MTF ILdd Revisited

D2.3 comment #85

Introduction – comment #85 from D2.3

IEEE P802.3dj Task Force

Figure 179B-2—Mated test fixtures insertion loss

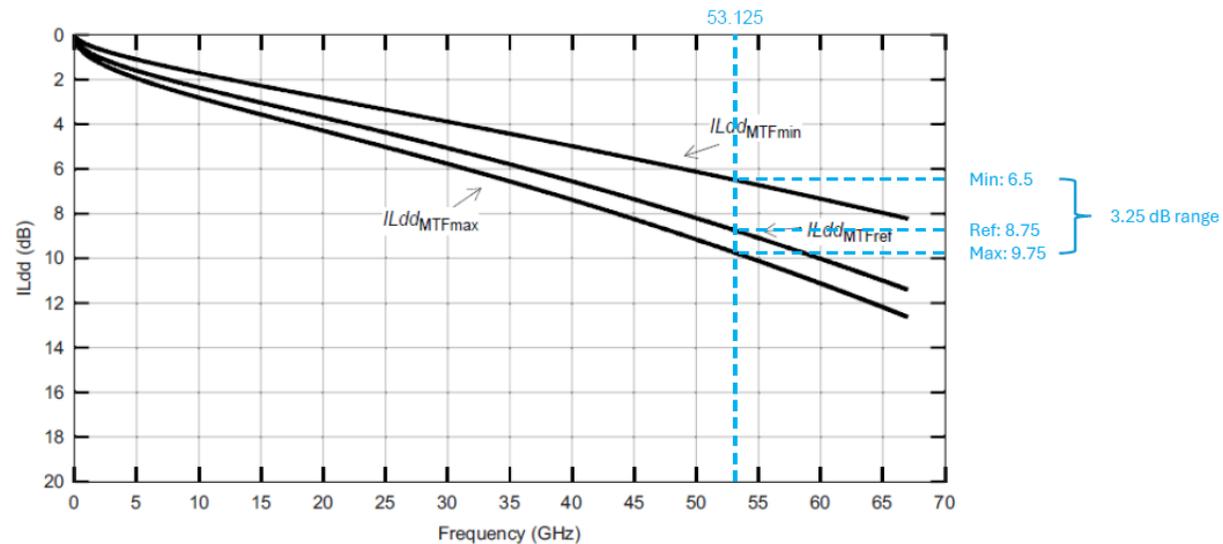
<i>CI</i> 179B	<i>SC</i> 179B.4.1	<i>P</i> 912	<i>L</i> 10	# 85
Ran, Adee		Cisco Systems		
<i>Comment Type</i>	T	<i>Comment Status</i>	R	<i>Test fixtures (E)</i>
<p>The difference between minimum and maximum ILdd for mated test fixtures is about 3 dB at the Nyquist frequency. This difference allows significant variations in cable assembly test fixture (MCB), which can have a double effect (up to 6 dB) if used to measure a cable.</p>				
<i>SuggestedRemedy</i>				
<p>Reduce the allowed variability of test fixtures, or its effect on measurements. A detailed proposal is planned.</p>				
<i>Response</i>		<i>Response Status</i>	C	
<p>REJECT. This comment does not apply to the substantive changes between IEEE P802.3dj D2.2 and D2.3. However, the commenter indicated that it is related to unsatisfied comment #306 against D2.2 (see <https://www.ieee802.org/3/dj/comments/D2p2/8023dj_D2p2_comments_final_id.pdf#page=84>), so it is considered in scope.</p> <p>The CRG has reviewed the following contributions: <https://www.ieee802.org/3/dj/public/26_01/ran_3dj_02_2601.pdf> <https://www.ieee802.org/3/dj/public/26_01/mammenga_3dj_01_2601.pdf></p> <p>Note the the draft states that "The effects of differences between the insertion loss of an actual test fixture and the reference insertion loss are to be accounted for in the measurements".</p> <p>The comment suggests changes that are a potential improvement, but the specific details are not clear.</p> <p>The discussion did not show consensus for any of the directions in the presentation.</p> <p>Future work and consensus building on this topic are encouraged. There was no consensus to make a change.</p>

<i>CI</i> 179B	<i>SC</i> 179B.4.2	<i>P</i> 905	<i>L</i> 20	# 306
Noujeim, Leesa		Google		
<i>Comment Type</i>	TR	<i>Comment Status</i>	R	<i>test fixtures (E)</i>
<p>lidd_MTFmin is, at fNyquist, 4dB lower than lidd_MTFmax. This large allowed variation in MTF IL introduces too much uncertainty as to whether a given DUT (host or cable assembly) passes or fails due to variation in the test fixture.</p>				
<i>SuggestedRemedy</i>				
<p>Decrease the spread between ILddMTFmin and ILddMTFmax to ~2dB, by adjusting equations 179B-3 and 179B-4.</p>				
<i>Response</i>		<i>Response Status</i>	U	
<p>REJECT. The comment identifies an area for potential improvement in the current draft. However, the suggested remedy does not provide sufficient detail to implement. A contribution with a detailed proposal would be helpful for the CRG to drive consensus on a specific change.</p>

Mated Test Fixture (MTF) ILdd

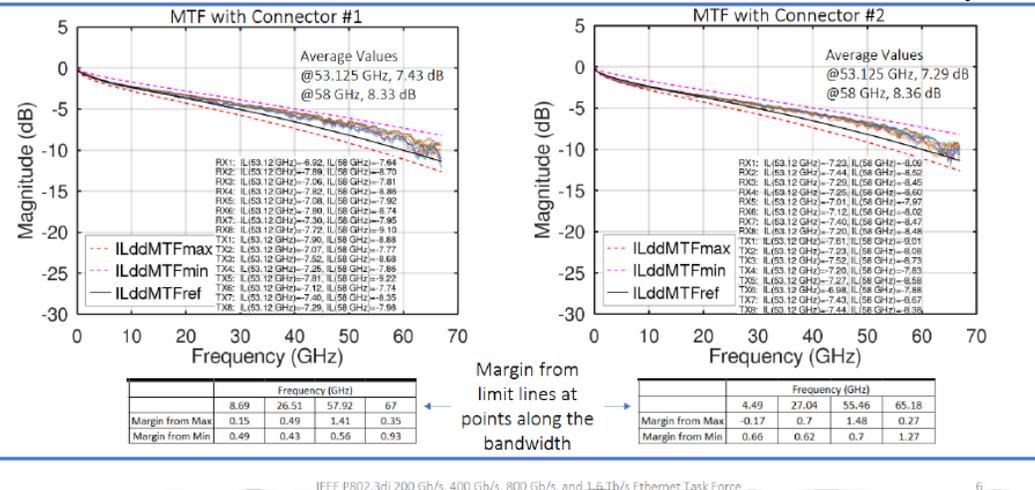
Variation between lanes on the same MTF is significant – at 53.125 GHz, 0.98 dB for “connector #1”, 0.69 dB for “connector #2”. There is a larger variation above 53.125 GHz

The differences seem mainly in the ripple.

The range can be tightened somewhat by raising the “max” line (and the reference line)... But this might coincide with manufacturing variations and yield
